**RESOLUTION SETTING HEARING ON REQUEST FROM RIVER POINT WEST, LLC TO AMEND PUD CONCEPTUAL PLAN FOR PROPERTY LOCATED AT 205 SOUTHWEST 11<sup>TH</sup> STREET**

(ZON2019-00206)

SHERMAN OFFICE SITE  
AMENDMENT PUD - TEXT

Drawing  
 BUILDING ELEVATIONS -  
 PUD AMENDMENT  
 SUBMITTAL

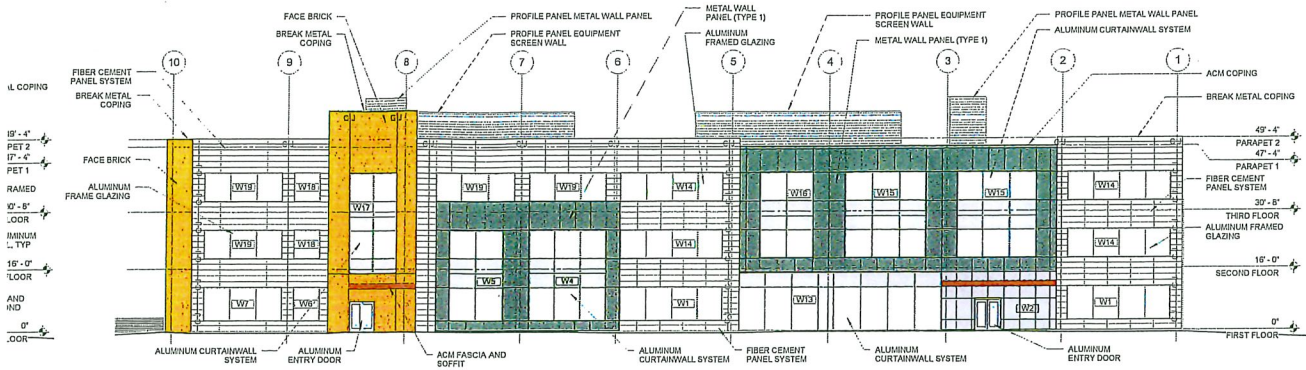
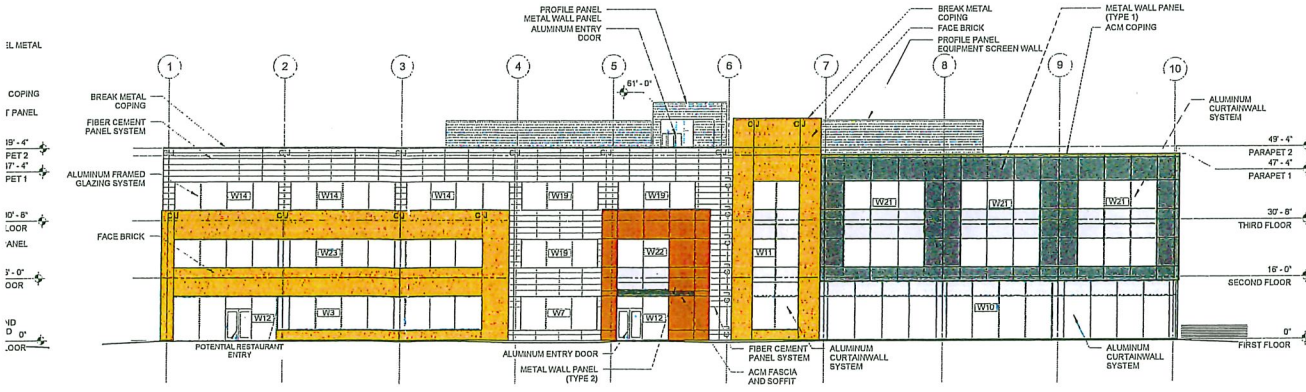
The proposed elevations indicate that the building would have a primary entrance on its north façade facing West Martin Luther King, Jr. Parkway and a primary entrance on its south façade facing the parking lot. The elevations also indicate that the restaurant space at the west edge of the ground floor would have entrances to both the north and south. Staff recommends that the proposed building should have a more prominent entry feature oriented toward West Martin Luther King, Jr. Parkway to the satisfaction of the City's Planning Administrator.

The proposed elevations indicate that the hotel building would be 3 stories with a maximum height of 49.5 feet, excluding the screening materials for rooftop mechanical equipment. The elevations indicate that the building would be clad with a mix of brick

and metal panels. Staff recommends that a note be added to the PUD Conceptual Plan to state that all rooftop mechanical equipment must be screened on all sides to a height equal to the tallest rooftop mechanical equipment, with materials that are architecturally compatible with the existing structure.

2. The PUD Conceptual Plan shall include a note that states the final design of the building shall be approved by the City's Planning Administrator.
3. The proposed building shall have a more prominent entry feature oriented toward West Martin Luther King, Jr. Parkway to the satisfaction of the City's Planning Administrator.

4. All rooftop mechanical equipment shall be screened on all sides to a height equal to the tallest rooftop mechanical equipment, with materials that are architecturally compatible with the existing structure.
